WEST OXFORDSHIRE LOCAL PLAN

**LANDSCAPE AND VISUAL REVIEW OF TWO ADDITIONAL SUBMISSIONS FOR
WITNEY STRATEGIC DEVELOPMENT OPTIONS
JANUARY 2015**

LANDSCAPE AND VISUAL REVIEW OF TWO ADDITIONAL SUBMISSIONS FOR WITNEY STRATEGIC DEVELOPMENT OPTIONS

FIGURE 1E: SOUTH WITNEY

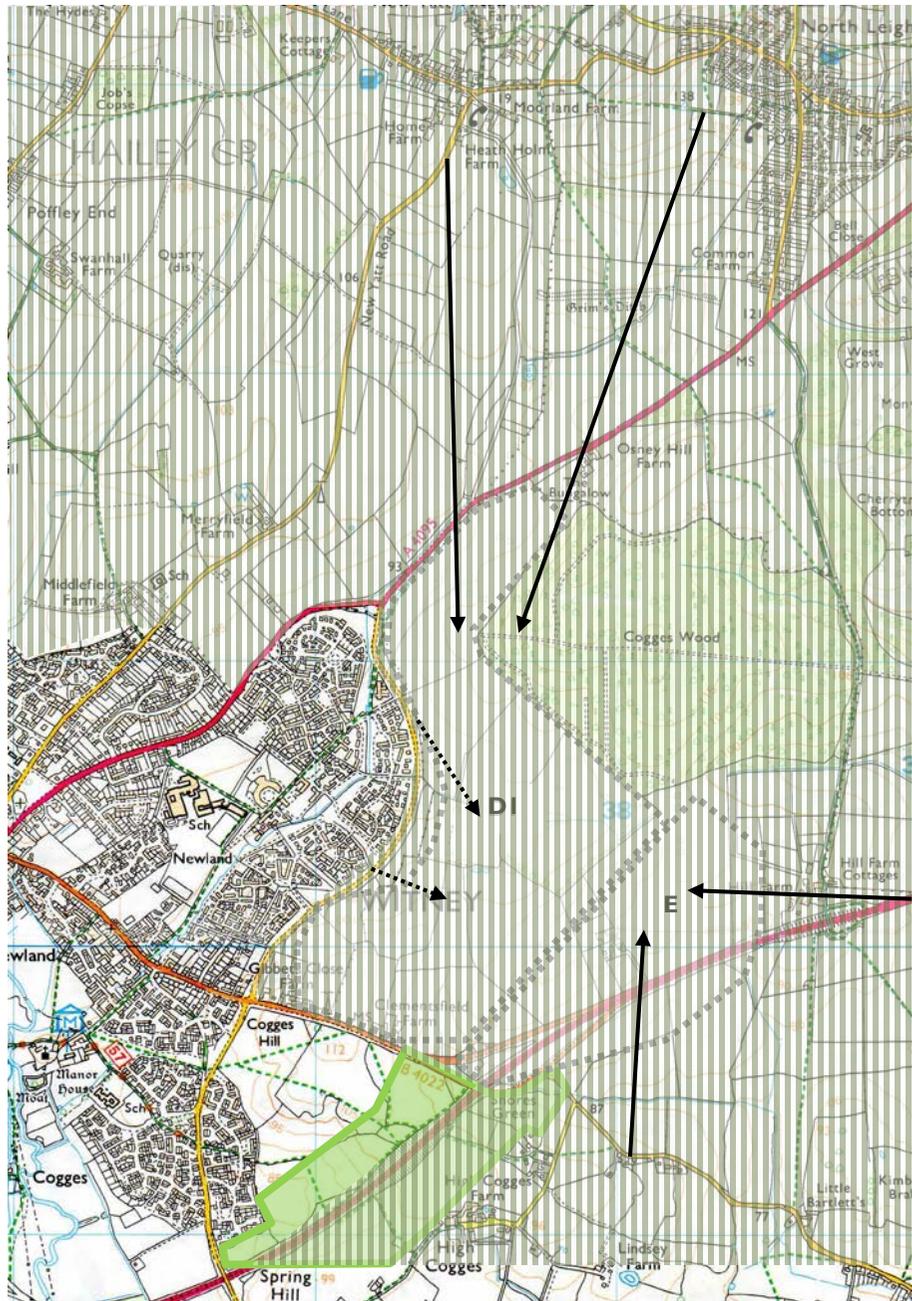
The site lies within two AHLC character areas F2 and G. Development within parts of F2 and G might be acceptable in landscape and visual terms subject to the landscape design objectives set out below. Development within F2 and G as proposed, would damage the landscape and visual separation of the historic settlement of Curbridge from Witney and have a significant adverse impact on the open landscape which separates Curbridge from Ducklington and which links into the wider landscape south of Curbridge Lane. It is important that an appropriate landscape buffer be retained to protect both villages (see Figure 1E). The built form on the southern edge of Witney however has a negative impact on the rural landscape quality and although the local field pattern is largely intact, the immediate landscape and visual setting of Witney has been eroded, although many significant landscape elements remain such as the distinctive valley feature (reinforced by perimeter planting of historic origin), hedgerows, open pasture and wider agricultural landscape. If development were to be allocated to this site, it is essential that this pattern is conserved and protected from adverse impact from local development. The need to protect and enhance the key landscape, visual and settlement characteristics of this area must lead to a restriction on the extent of the development. In this respect I disagree with the recommendations for mitigation set out in the submitted LVA. These are insufficient to properly and fully mitigate the harm arising from development as proposed in the current Abbey Development Ltd site option submission.

It is recommended from a landscape perspective that if the South Witney option is pursued further, major revisions will be needed to the extent of development and a revised comprehensive Green Infrastructure masterplan prepared for the site. The number of potential dwellings will need to be reduced significantly in order to protect important landscape, visual and townscape features of the area. The development footprint should reflect the existing footprint of Ducklington, to avoid an urban extension which is out of scale. Separation from both Ducklington and Curbridge could create a contained small settlement.

- Extent of development area to be no further south than the existing southern edge of the sewage/abattoir works and the brook;
- Brook valley corridor to be conserved as a key dominant feature of the site and used to define the southern edge of the development area;

- Open landscape proposed in the site option to the west of Ducklington to be included and extended along the north side of Curbridge Lane as far as the A4095;

- Buffer to Curbridge to be widened to ensure landscape and visual separation and maintain the separate identity of the village;
- Vegetation buffers to be substantial and to reflect local landscape pattern in order to screen the built form;

- Retain hedgerow pattern and railway line link as shown in site option;
- Improve footpath links generally along Green Infrastructure corridors;
- Highway access to be provided as shown in the site option, taking advantage of tree and woodland belts to screen highway works from the wider landscape.
